**ADDENDUM #1
RESPONSE TO QUESTIONS
Liberty Hills Sanitary Sewer Rehabilitation Project**

DELAWARE COUNTY, OHIO
JEWETT ROAD
SANITARY SEWER IMPROVEMENTS
STA 59+50.00 TO STA 63+67.14

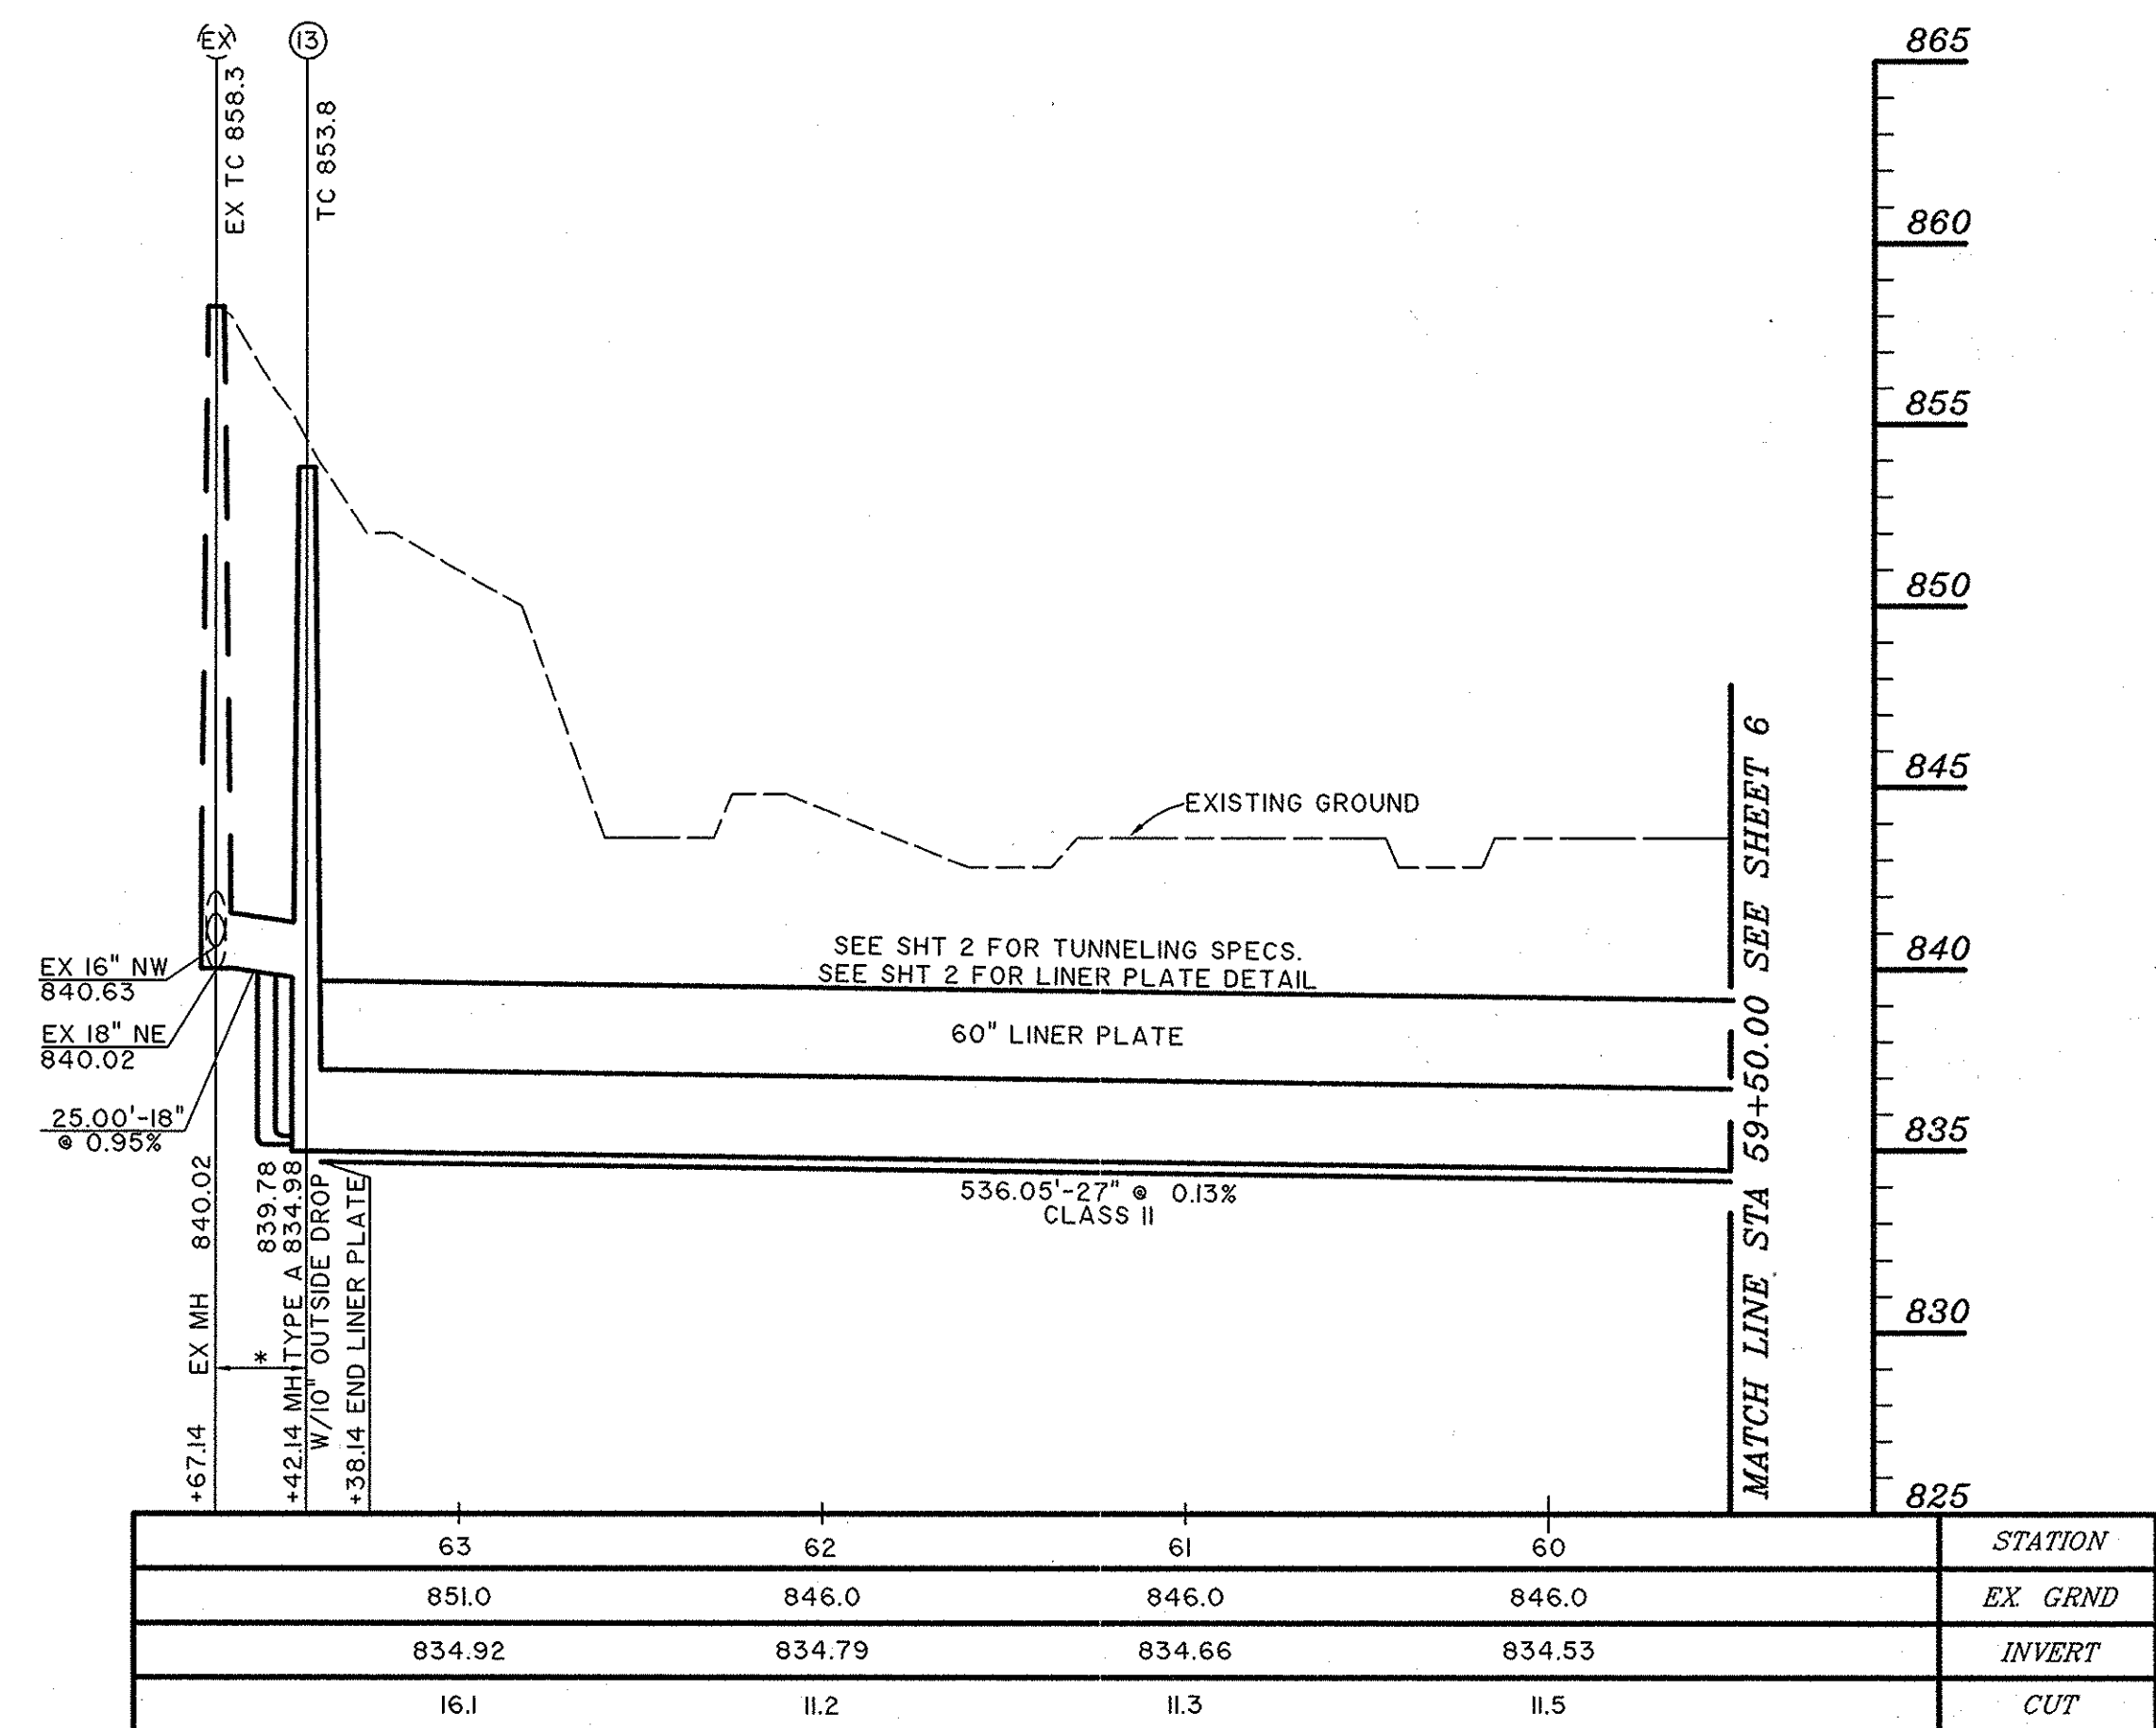
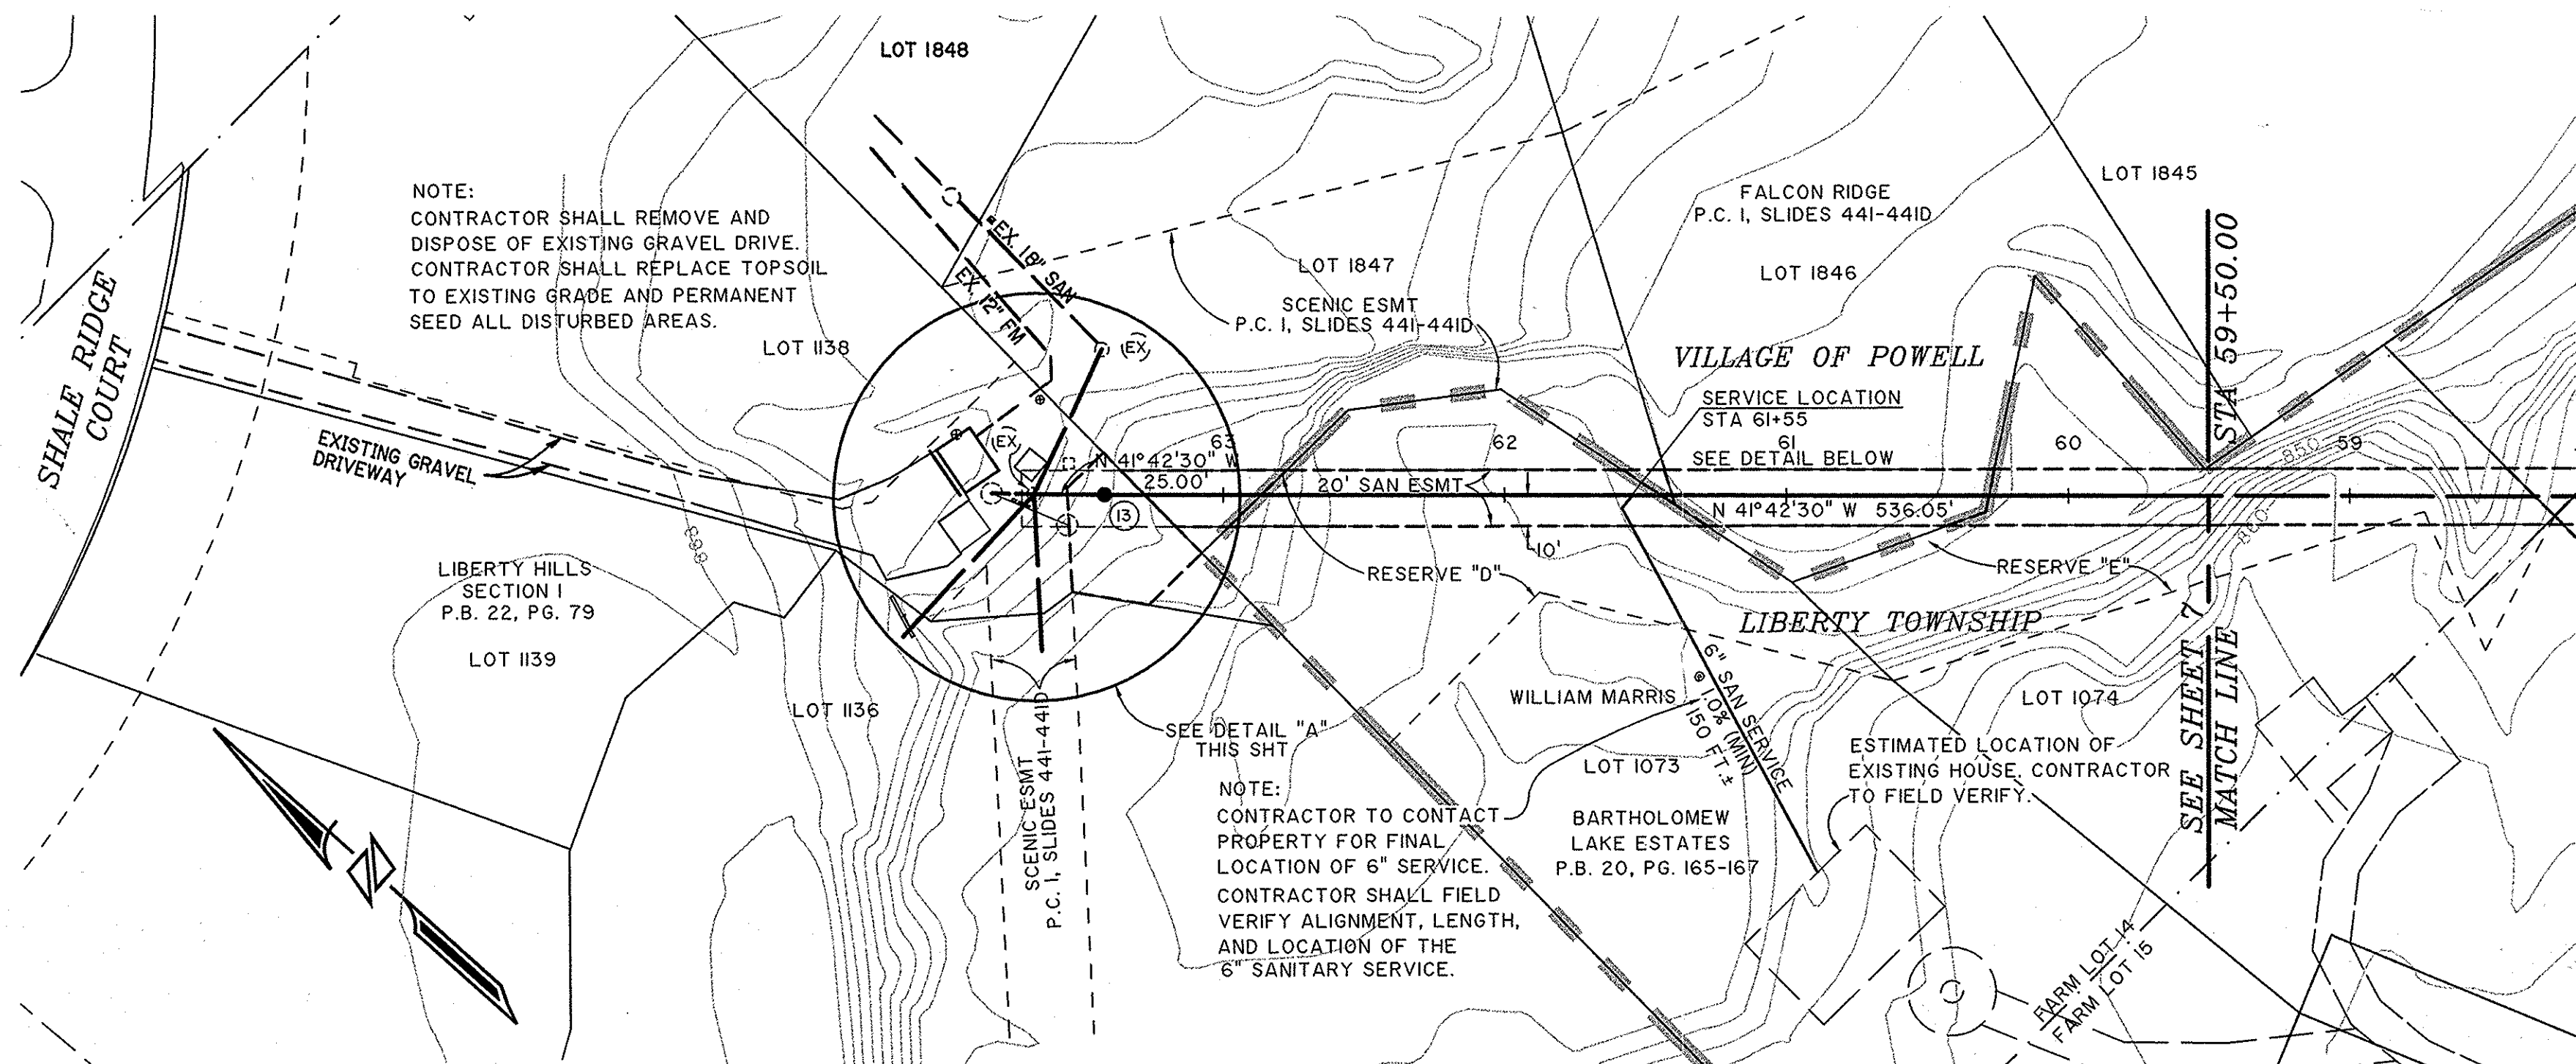
4. Can record plans for the 27" concrete sewer inside of the 60" casing pipe be provided?

YES – SEE ATTACHMENT 2 TO THIS RESPONSE TO QUESTIONS.
